H2Teesside Project

The H2 Teesside Order

Document Reference: 8.11.15 Response to ExQ1 Surface Water, Flood Risk and Water Resources

Date: October 2024

FIGURE NUMBER
Figure 1

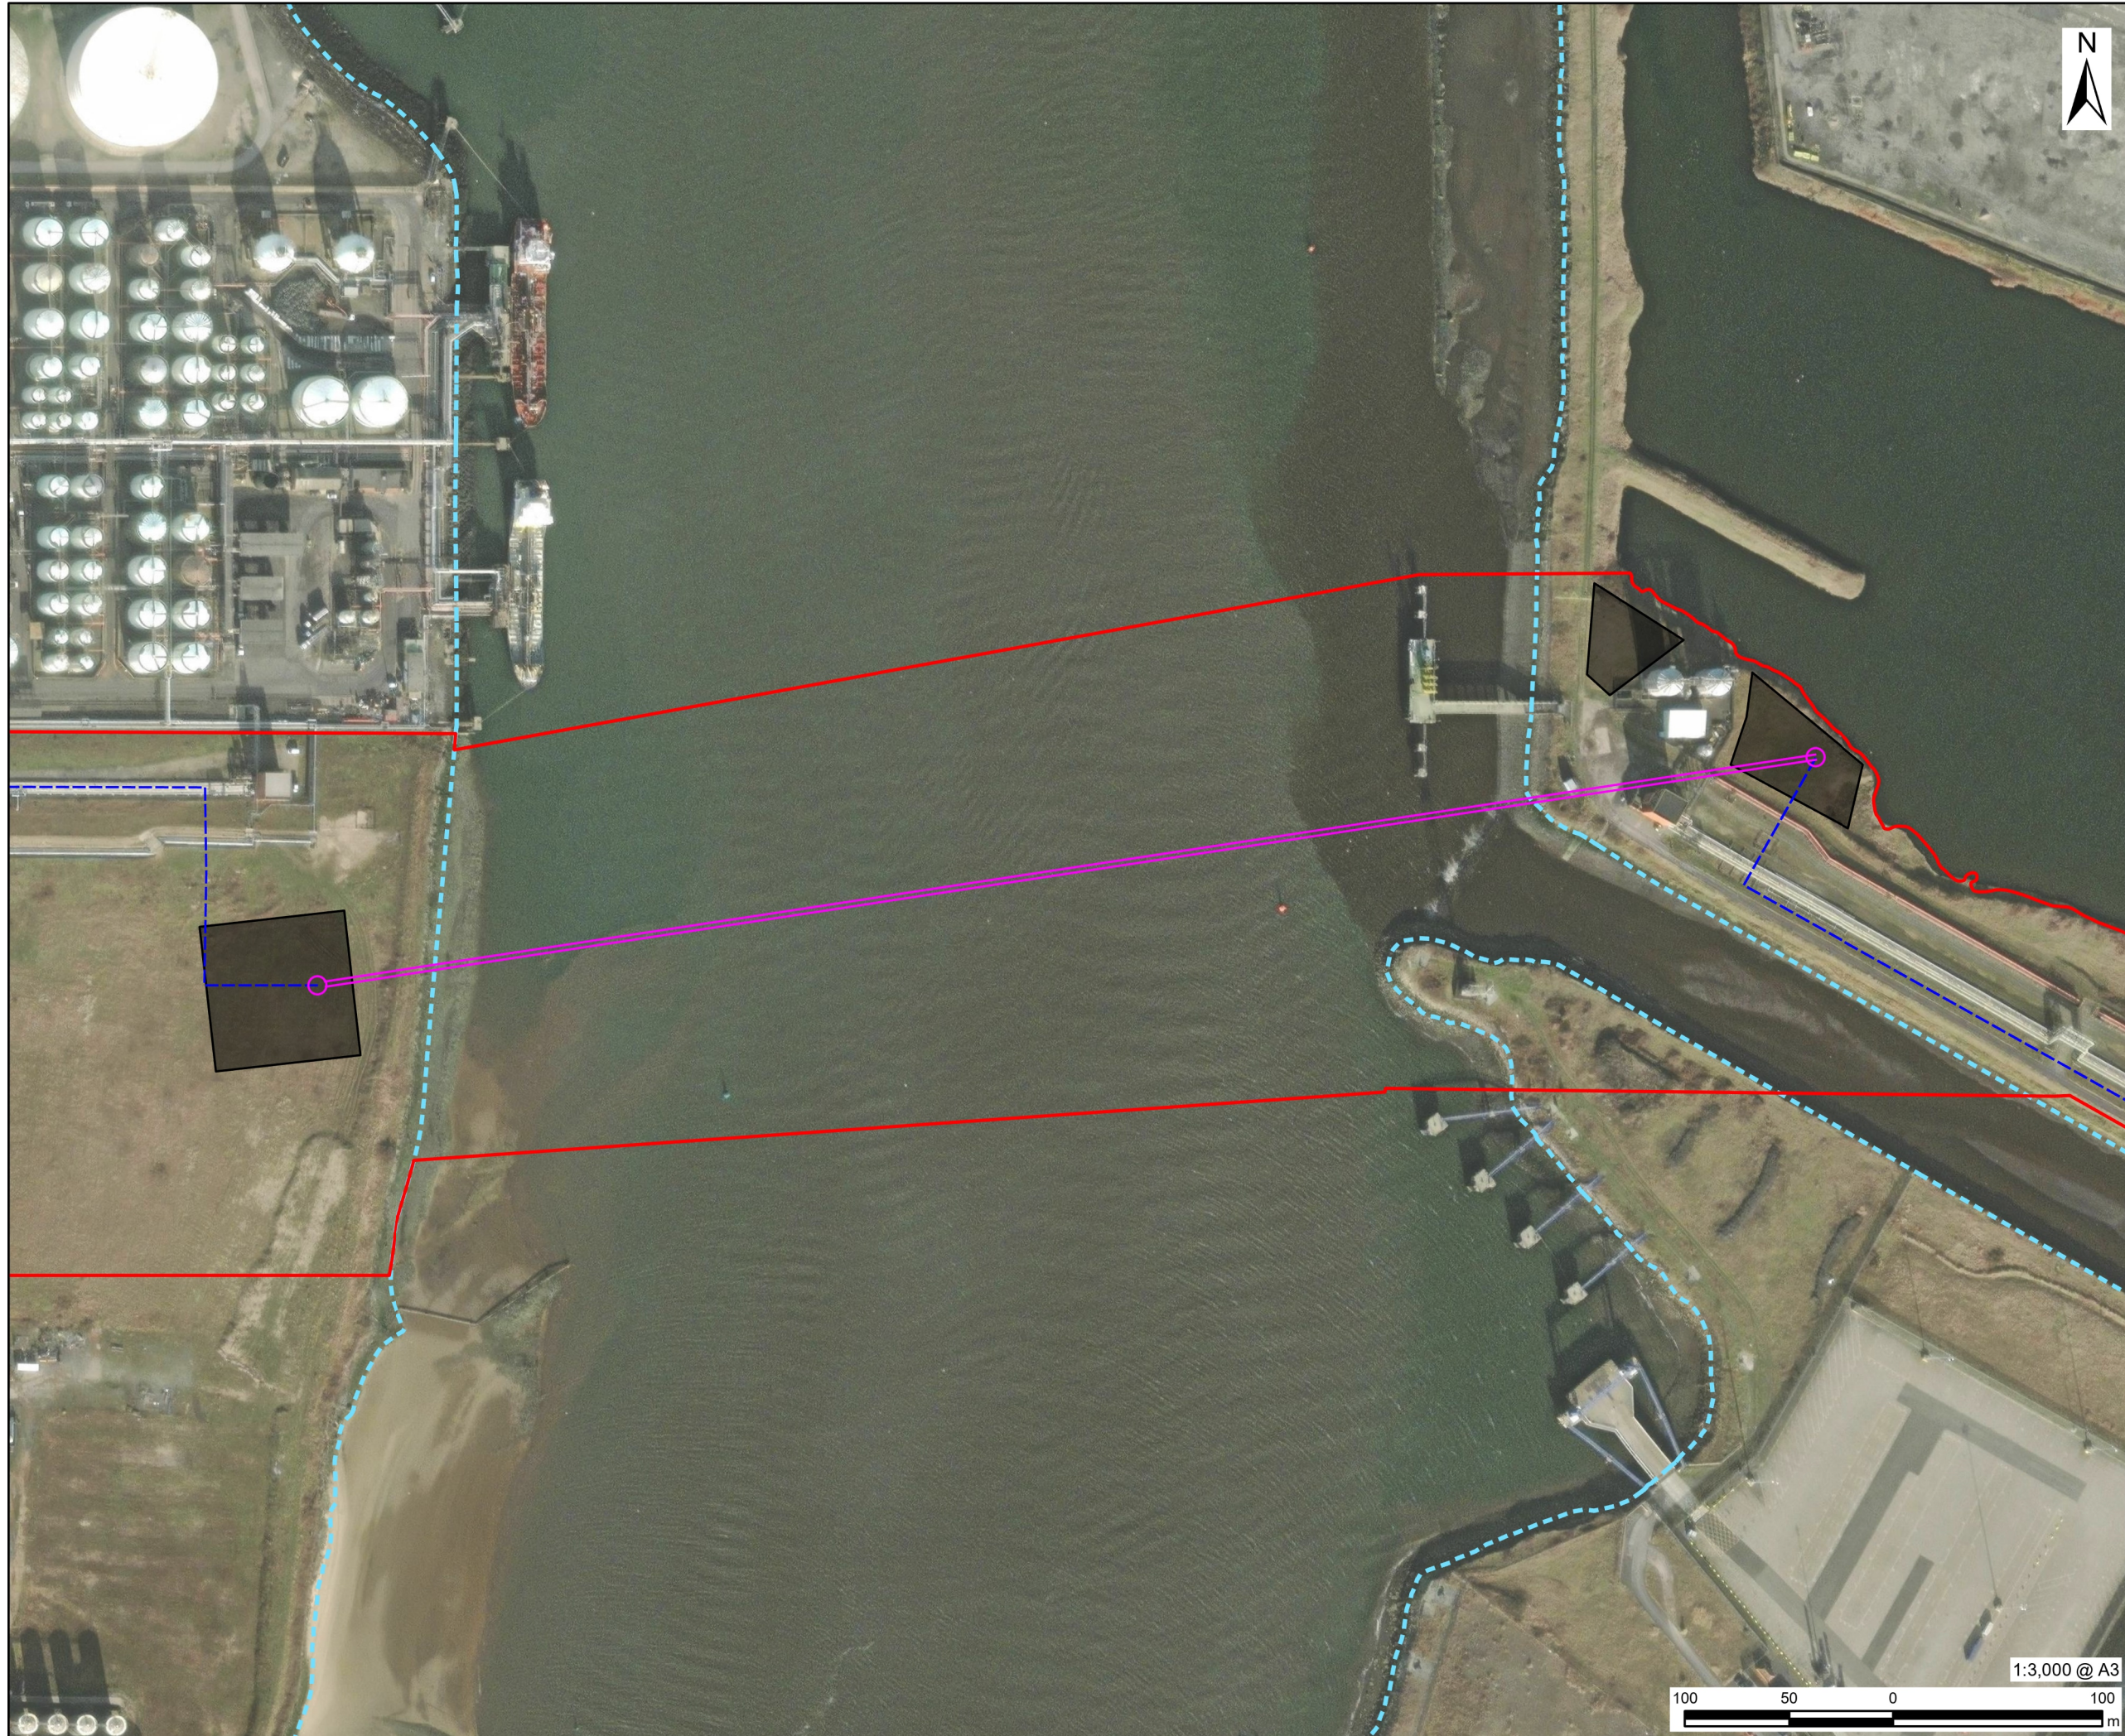
EXQ1	QUESTION TO:	QUESTION:	RESPONSE
		<p>The Marine Management Organisation in its RR [RR-021] advises “<i>It is unclear whether the entry and exit pits for the trenchless crossings are above Mean High Water Springs...</i>” (Paragraph 4.1.1) and that section 4.10 of ES Chapter 4 (Proposed Development) [APP-056] does not present a map detailing these locations. Please provide such a plan or signpost the ExA as to where in the submitted Application Documentation such a plan is to be found.</p>	<p>1) to illustrate this is the case . This has been shared with the Marine Management Organisation.</p>

Q1.15.6	Applicant	Clarification/ Information sought.	<p>It can be confirmed that the entry and exit points for trenchless crossings are above Mean High Water Springs. Figures 1 to 4 have been appended to these responses (see Appendix</p>
